CCL Ref: 14649-260721-haynes

## **Response to Central Otago District Council Comments on the Wooing Tree Application**

Further to recent e-mails, we understand that Central Otago District Council has provided transportation comments on the Wooing Tree application (via Antoni Facey of consultants Avanzar). This letter responds to the comments made. To assist reading, the particular paragraphs being addressed are listed first followed by our response, and our response has been informed by discussions with Mr John Duthie.

**Figure 1: Sketch Layout for Internal Intersection**

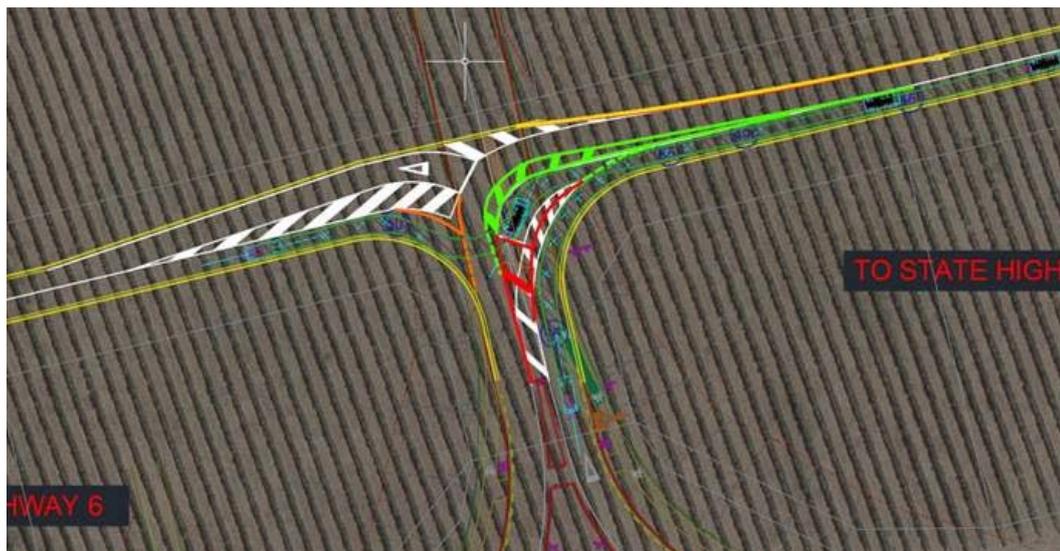
Since the application was lodged, there have been ongoing discussions with Waka Kotahi NZ Transport Agency on this matter. As part of this, we produced a detailed Technical Note that assessed how the intersection would operate with regard to the interaction with the roundabout and as part of this we set out a range of alternative options.

Based on information received, we understand that a position has been reached that is acceptable to the Applicant and Waka Kotahi whereby the main entry road into the development will now curve around to the east (we note Mr Facey was copied into this email trail). We anticipate that a revised intersection layout of this nature will address the concerns expressed by Mr Facey on this matter.

We have been provided with a preliminary sketch of the layout (produced by consultants WSP) which illustrates the concept.

For clarity, the roundabout design produced by WSP shows that the traffic speed on the Wooing Tree access and on the circulating carriageway of the roundabout is expected to be 40km/h, rather than the 50km/h assumed by Mr Facey.

**Figure 2: Underpass Location**

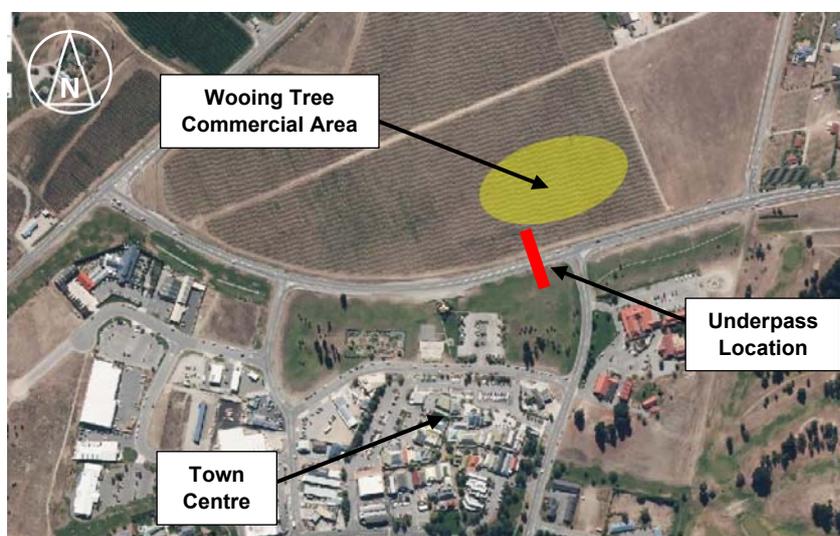
In practice, the underpass must either be located to the east or west of the roundabout, and the roundabout location is fixed. In the event that the underpass was located towards the east, rather than the west as presently proposed, many of the same issues identified by Mr Facey would remain.

However when considering features such as an underpass, the original and destination of travellers within a wider context is a relevant matter. In this case, the underpass lies on the desire line between the commercial activities within the site and Cromwell town centre, and therefore on a route that it could reasonably be expected pedestrians will seek to use. In other words, pedestrians will not have to deviate from their natural route in order to use the underpass.

We do not agree that the underpass will necessarily be difficult to find – rather, we anticipate that appropriate signage and roading treatments will be provided as a matter of course to support the conspicuity/legibility of the route.
